### ULTRALIGHT AIRCRAFT AD NOTICE

#### ALL SKYFOX AND GAZELLE AIRCRAFT- AILERON ROD END FAILURE

### SERVICE BULLETIN NO. 21

#### AILERON CONTROL SYSTEM SECURITY - MOD. 12/97

VIEWED FROM ABOVE

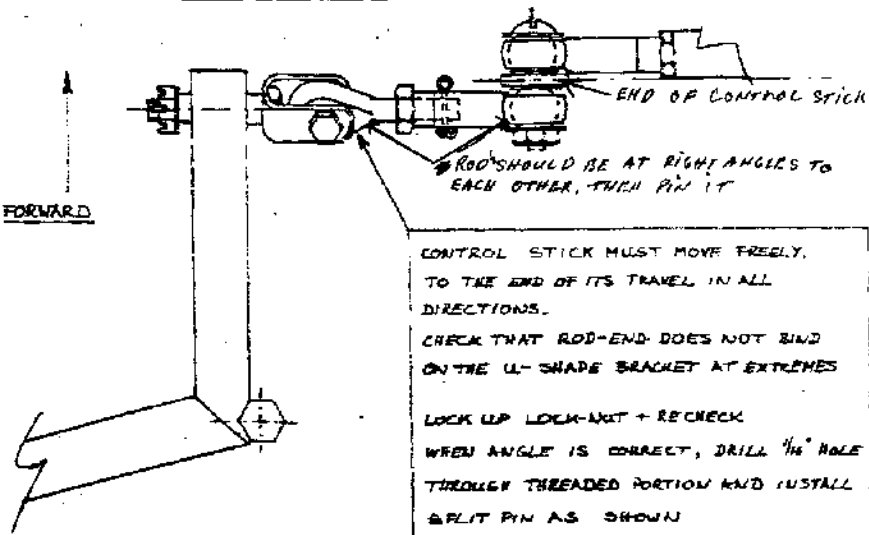
Current production models of CA25 and CA25N aircraft now have a split pin installed in the aileron control rod ends at the L.H. side (looking forward) of the control stick assembly.

Control stick must move freely, to the end of its travel in all directions. Check that rod end does not bind on the u-shape bracket at extremes. Lock up lock nut and recheck, when angle is correct, see the drawing on Page 2, drill 1/16" hole through threaded portion and install split pin as shown.

If on inspection the Rod Ends are bent then replacement is also required. They must be aligned correctly (the two ball ends at right angle to each other) and reinstalled in accordance with **SKY FOX service bulletin no 21**.

Stainless split pin, 1 x MS 24665 or AN 381-2-12 or equivalent.
